## Change Order

**PROJECT:** *(Name and address)*  
2023 Capital Outlay Project  
OFA / Golden Dome  
Ogdensburg City School District  
1100 State Street  
Ogdensburg, New York

**CHANGE ORDER INFORMATION:**  
Change Order Number: 1-01  
Date: August 8, 2023

1 L220

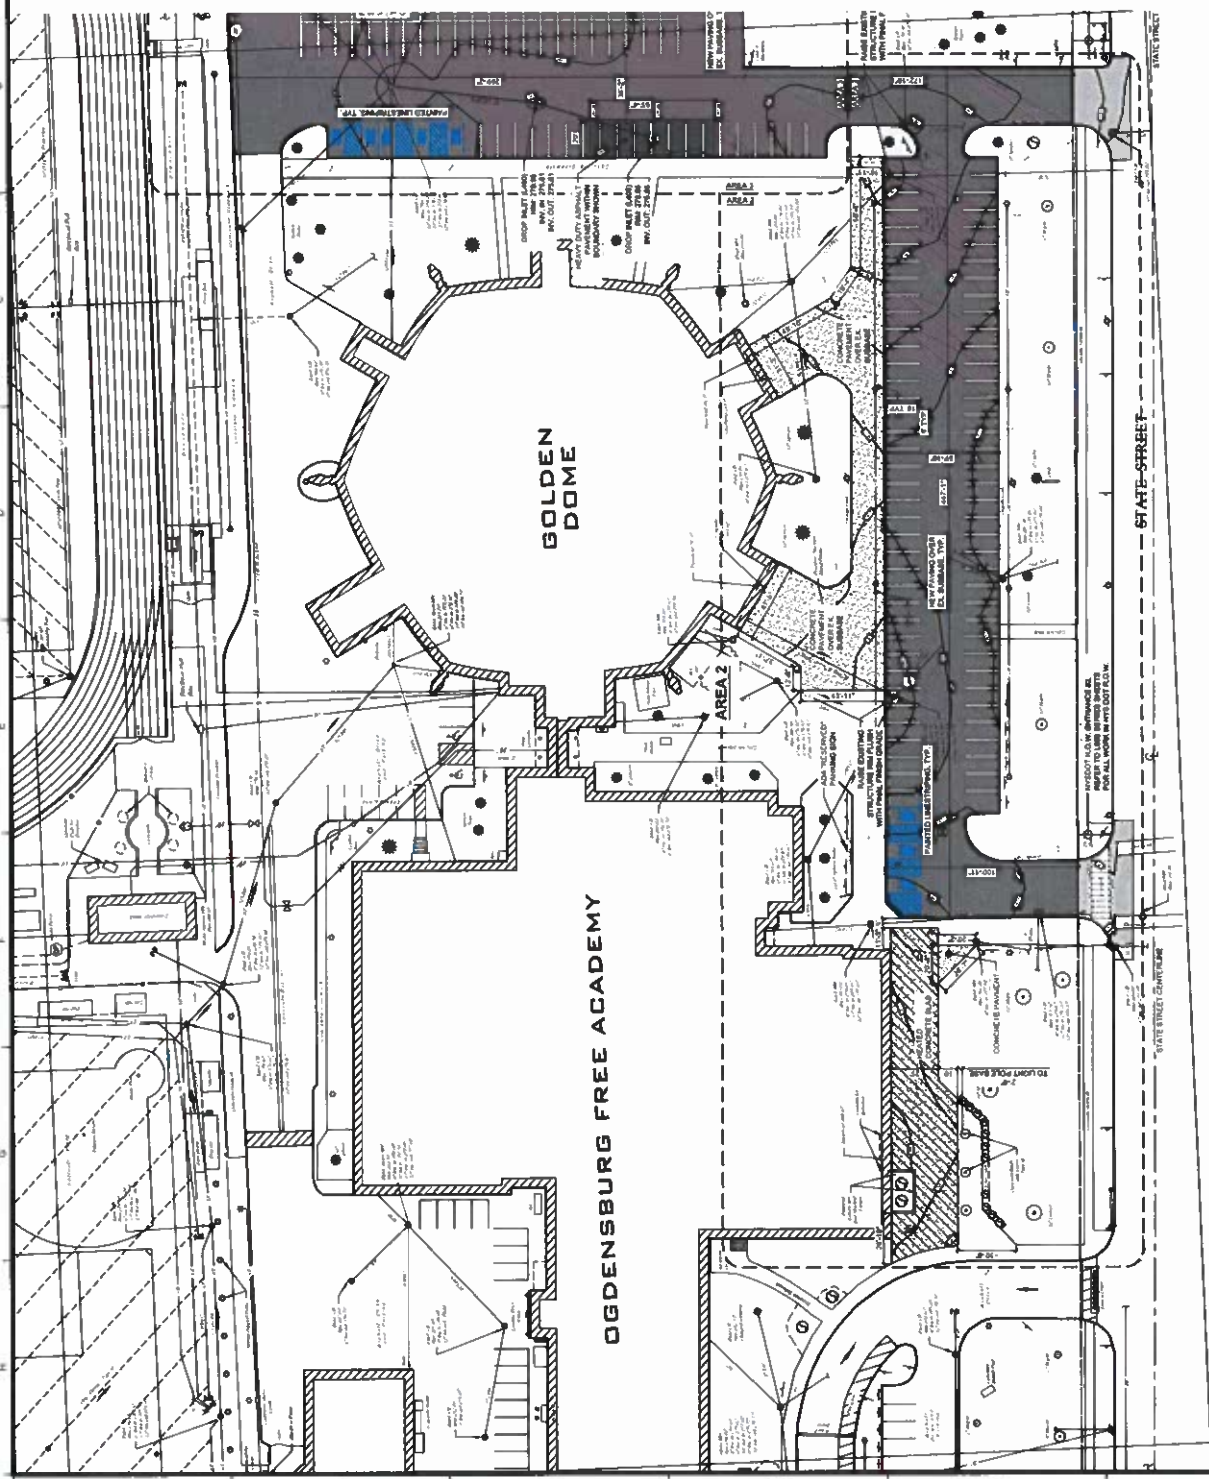
Add to provide all labor, materials, and equipment to replace deteriorated concrete sidewalk from Ogdensburg Free Academy to State Street in accordance with unit pricing as per the Form of Proposal for Contract No. 1 - General Construction.

A	Owner
B	Under the Capital Outlay Project, existing sidewalks were scheduled to be replaced as per Contract Drawing L220 & L320.
C	With favorable bid results, the Owner requested that an additional section of deteriorated concrete sidewalk be replaced from the scheduled work area in front of Ogdensburg Free Academy to State Street. As such, the General Contractor replaced an additional area of concrete sidewalk adjacent to the scheduled new heated sidewalks in accordance with the unit price provided on their form of proposal. Note that the Owner only received a single bid under Contract No. 1 -General Construction for the 2023 Capital Outlay Project.
D	Add to provide all labor, materials, and equipment to replace deteriorated concrete sidewalk from Ogdensburg Free Academy to State Street in accordance with unit pricing as per the Form of Proposal for Contract No. 1 - General Construction.

Area 1: Adjacent to the new heated sidewalk 1,235SF @ \$50/SF = \$61,750
